PLANNING & DEVELOPMENT REPORT

Subject: Plan of Subdivision Application 30T-22501
Zoning By-law Amendment Application ZBA 05-22
Applicant: Strohvest Ontario Inc.
Location: Gerber Road

**RE: Township Comments – Revised Submission June 2024
Plan of Subdivision Application 30T-22501
Zoning By-law Amendment ZBA 05-22
Applicant: Strohvest Ontario Inc.
Location: Gerber Road, Township of Wellesley**

Attachment 2 – Revised Draft Plan of Subdivision – June 2024

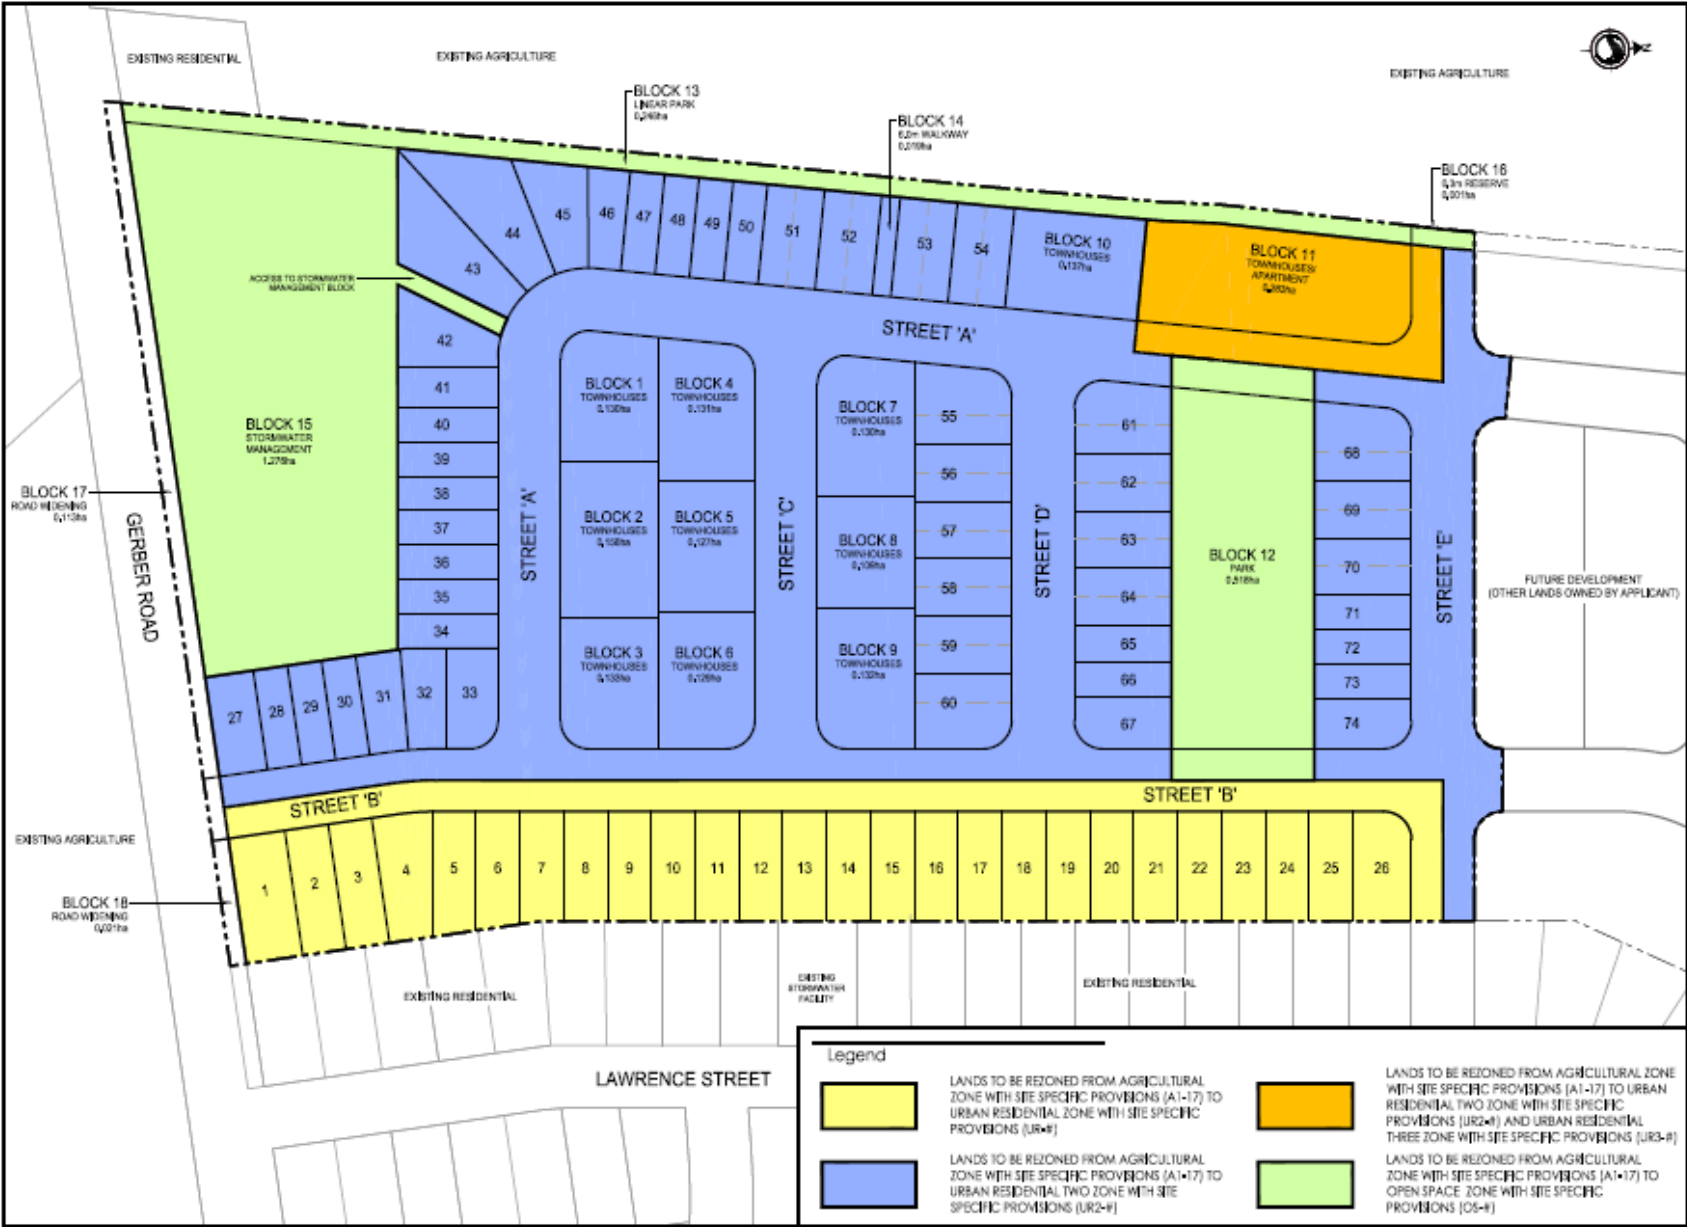
Comment Reference #	Township Response
A2.0 (Block 11 Zoning)	Staff support and appreciate the addition of Block 11 as a higher density block, capable of supporting a broader range of more affordable/attainable housing types. However, staff recommend that the following zoning regulations for this block be revised as follows:

<p>Minimum Rear Yard Width: 5.0m (adjacent to Block 10)</p> <p>Minimum Landscaped Open Space: 30% and up to 10% may be in the form of indoor amenity space</p>
A4.1 (Phasing)	<p>Staff accept the applicant's rationale for developing the subdivision in one phase. Please be advised that the required letter of credit at the time of the subdivision agreement will need to reflect the full cost of services to be installed in one phase.</p>
A6.0 (Fencing)	<p>Township staff would be happy to meet to provide a rationale for fencing requirements. Key purposes of fencing are to delineate property boundaries, restrict access for safety or other purposes and reduce/prevent encroachments. To this end, staff require fencing in most instances over simple demarcation/bollards or "living fences" as staff find fencing to be more effective in the long term.</p> <p>In terms of Block 13 (Linear Park), staff will continue to require standard rear lot fencing for lots abutting the block, however staff concur that safety is also important. Therefore, staff would accept farm fencing along the western boundary of Block 13 as an alternative.</p> <p>In terms the stormwater management block (Block 15), staff note that the Township Development Standards (April 2017) state that "fencing of stormwater management facilities shall be discouraged; however it may be required as determined by the Township."(9.1.1.11). More recently, the Township (and most other municipalities) requires fencing around stormwater management facilities due to safety concerns and encroachment issues.</p> <p>In summary, staff will require fencing for the proposed subdivision in accordance with the table provided in Appendix 4.</p>
